CALIFORNIA COASTAL COMMISSION

STAFF REPORT: REGULAR CALENDAR

Consistency Determination No.: CD-011-13

Project Description: Demolition and replacement of the existing Navy fuel pier with associated dredging to widen an existing turning basin

Figure 3.1-2
Point Loma Ecological Conservation Area and Eelgrass Beds
in the Vicinity of the Proposed Fuel Pier

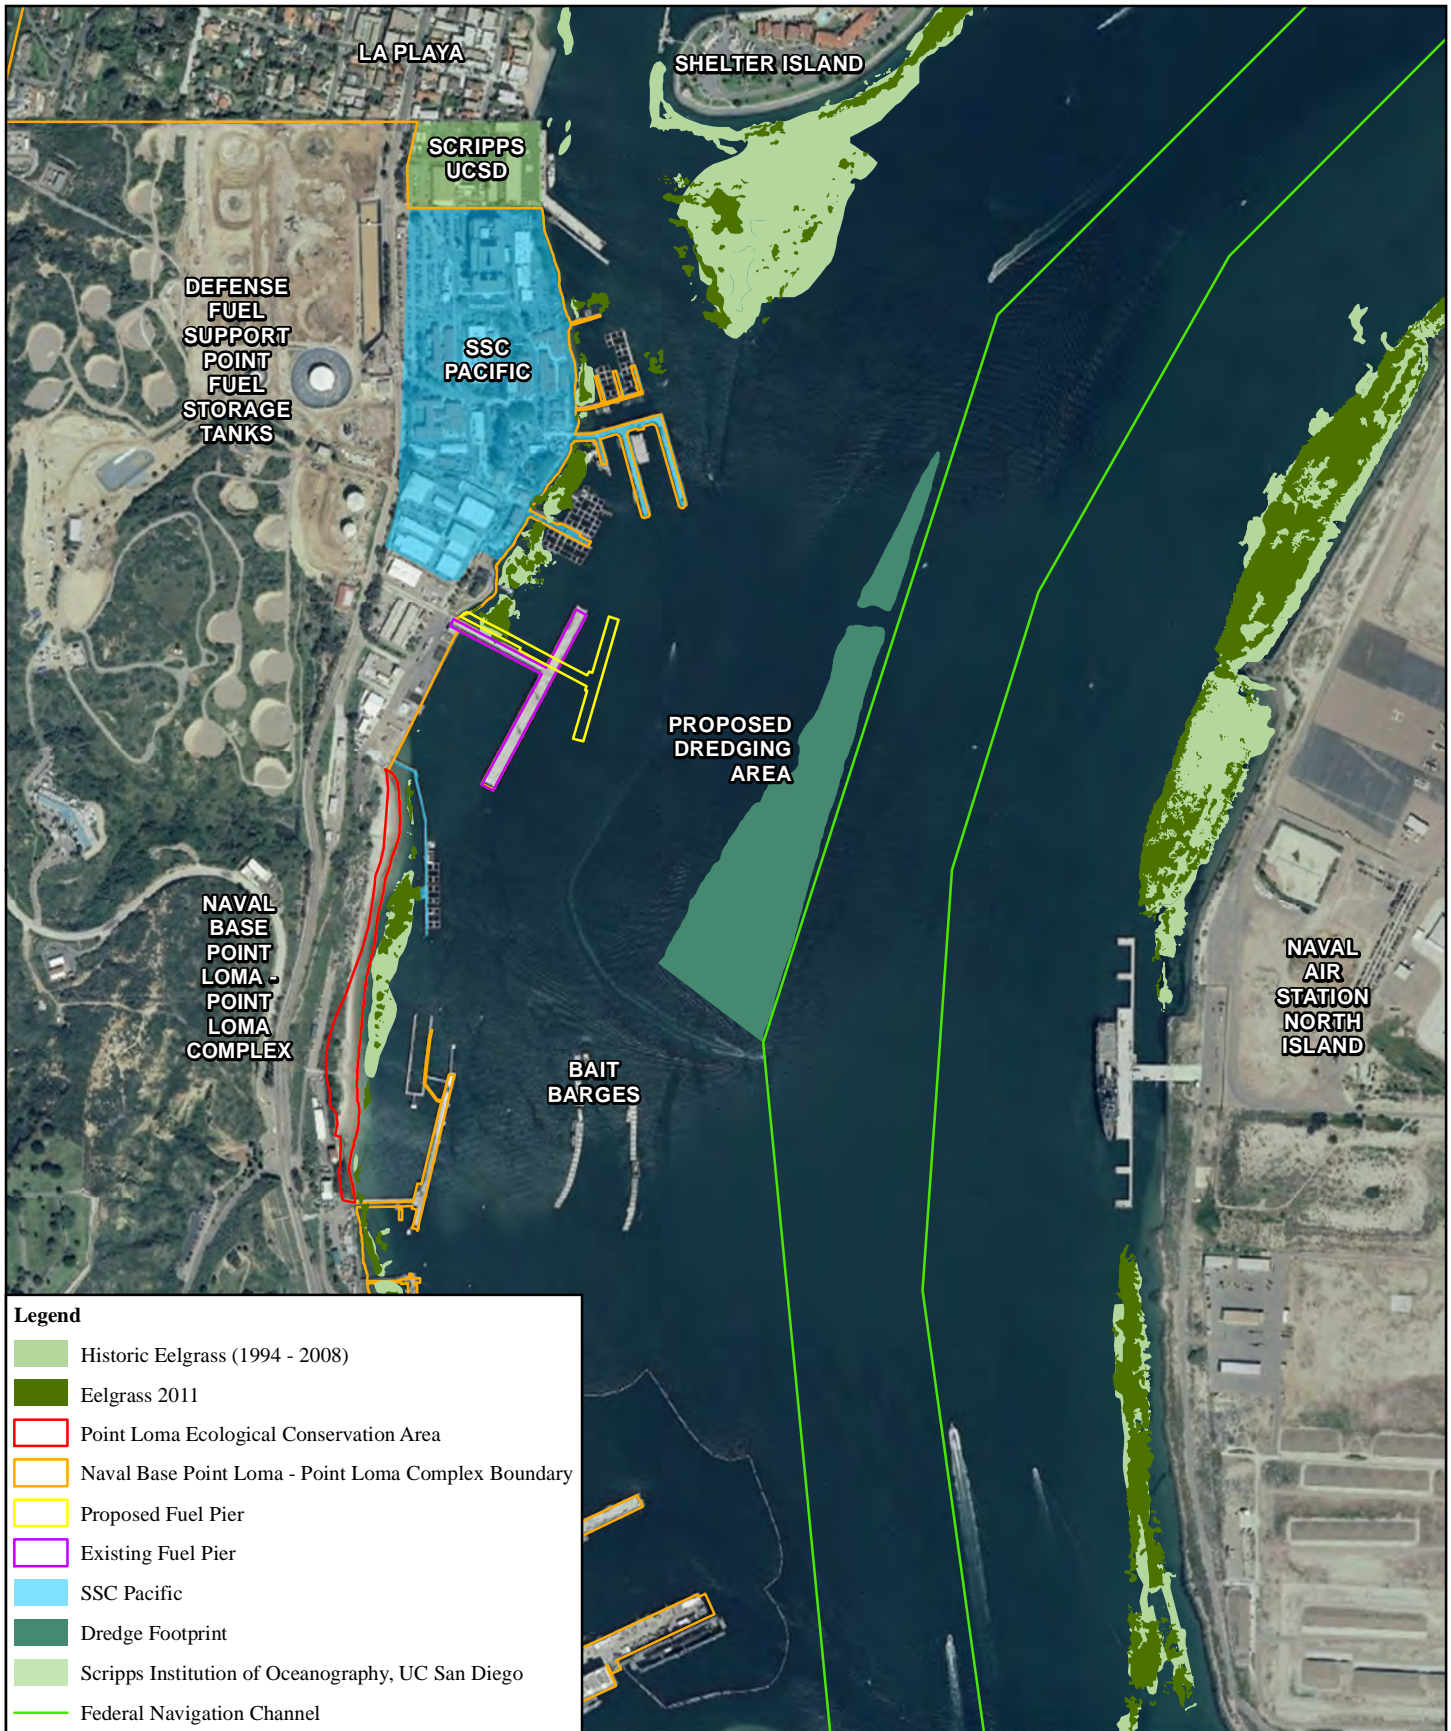
Eelgrass grows or historically grew in three primary locations within the project site (see Exhibit 7). The first is the area immediately north of the fuel pier. This stand of eelgrass extends from the fuel pier north over 1500 ft, and lies adjacent to the two northernmost marine mammal enclosure sites operated under the Navy's MMP. The second stand is located immediately to the west of the southernmost of the MMP's marine mammal enclosure sites, to the south of the fuel pier. The third site is located farther to the north and east at the proposed relocation site of the MMP.

The Navy anticipates that project activities will result in a small impact to eelgrass beds. During pier demolition and construction activities, approximately 0.05 acres of existing eelgrass (as surveyed in 2011) and 0.05 acres of habitat that historically supported

eelgrass would be permanently shaded by the new pier structure. An additional 0.67 acres of existing eelgrass and 0.32 acres of habitat that historically supported eelgrass would be partially shaded by the marine mammal enclosures at the proposed relocation site for the MMP. The bottoms of the enclosures are mesh and would thus allow some light to filter down to the eelgrass beds. The water quality impact to the eelgrass beds lying below the MMP is uncertain, although the eelgrass beds reside in an actively used marina, and are thus adapted to some level of water quality impairment. The impact to eelgrass at the proposed MMP relocation site would be temporary. Eelgrass populations should return to previous levels after the marine mammal enclosures are returned back to their current location. The dredge and sediment disposal sites do not support eelgrass habitat.

To minimize and address impacts to eelgrass beds, the Navy has proposed several avoidance and minimization measures. First, the Navy designed the proposed pier to minimize disturbance to eelgrass beds. The project will also result in a net decrease of 0.12 acres to the total area of San Diego Bay that is shaded. In addition, the Navy will leave sheet piling in place beneath the existing pier to minimize disturbance to eelgrass. Further, the Navy will conduct pre- and post-construction surveys of eelgrass habitat to quantify the actual project-related impact to existing and historical eelgrass populations. This impact will be offset using the Navy's established eelgrass mitigation bank. The MMP relocation site will be included in this survey, and impacts to eelgrass at this site will also be offset using the mitigation bank. However, upon successful reestablishment of eelgrass within impacted areas, the mitigation bank would be credited for the reestablished acreage. The Commission has historically found these types of measures adequate to protect, and where necessary, mitigate, impacts to eelgrass.

Figure 3.2-5
Underwater Sound from Impact Pile Driving at Marine Mammal
Relocation Site, 18" Concrete Piles (Source = 173 dB rms)

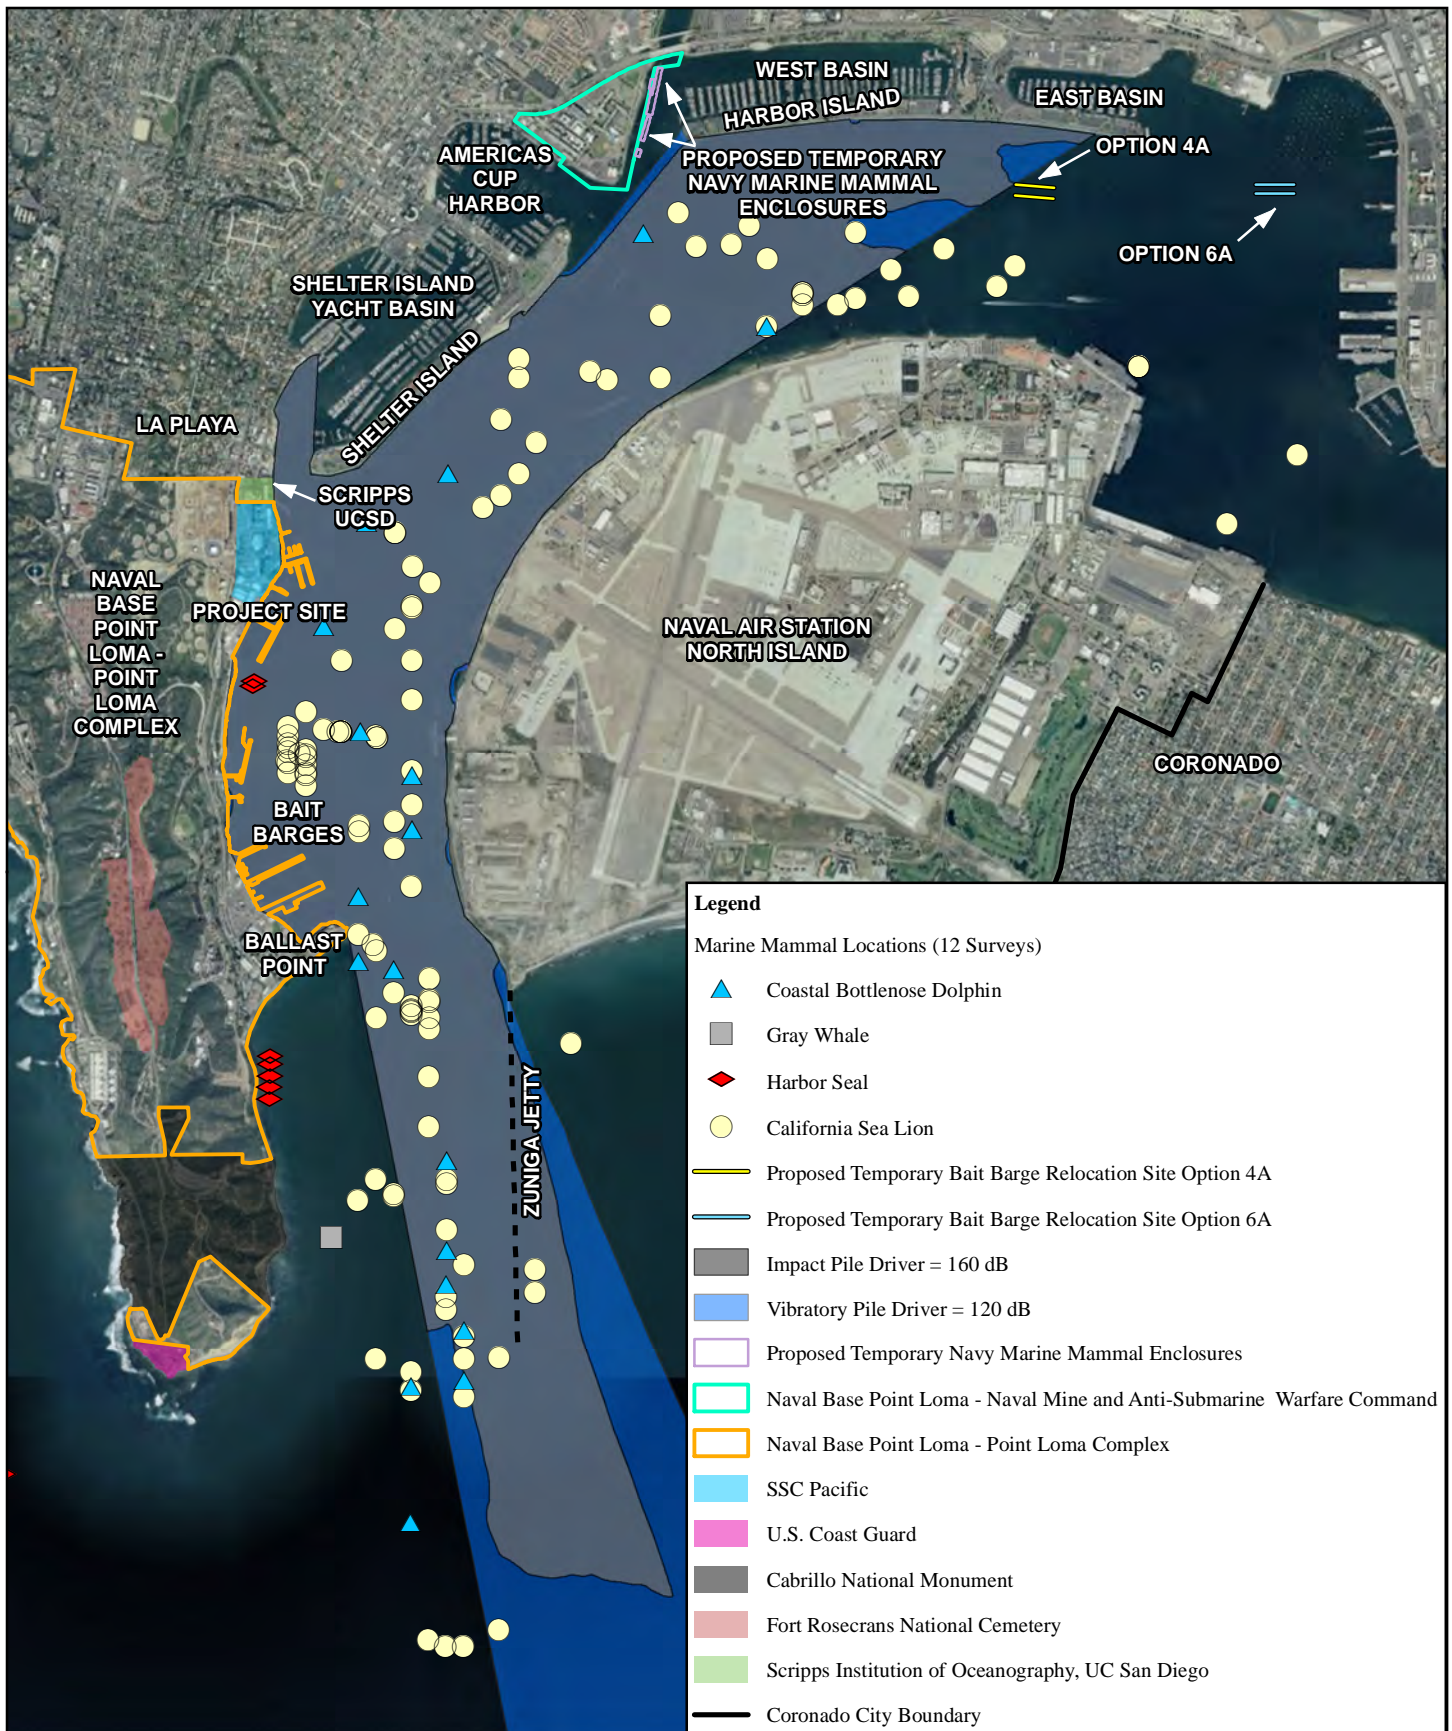
To evaluate potential impacts from project-related noise, the Navy developed an underwater sound model. This model calculated a Zone of Influence corresponding to the interim criteria discussed above for each type of noise-emitting project activity. These activities include impact pile driving, vibratory pile driving, and vibratory pile extraction. The model takes into account the type of activity – pile driving or pile extraction, type of equipment – impact or vibratory, and size and type of pile – steel, concrete and fiberglass of various diameters. Table 1 shows the calculated ZOI for fish based on model results. The table shows that impact pile driving of steel piles emits the highest level of noise, with a peak sound level at 210 dB measured at 10 meters. This type of activity also results in the most significant impact to fish. Impact pile driving is the only type of project activity that emits noise at levels that can cause injury to fish (206 dB), although this impact would be limited to a small area (approximately 0.0022 km²) within about 26 meters of the pile driver. However, the ZOI for behavioral impacts to fish is quite large, covering 10.8 km². Exhibit 8 shows the corresponding sound contours for impact pile driving of steel piles at the pier on a map of the project site and surrounding areas. Pile driving would also be necessary during construction of the temporary relocation site for the MMP. The piles at this site would be concrete, not steel, and thus the peak level of noise and the corresponding ZOI is smaller (i.e., 184 dB peak). Exhibit 9 shows the ZOI map for this site.
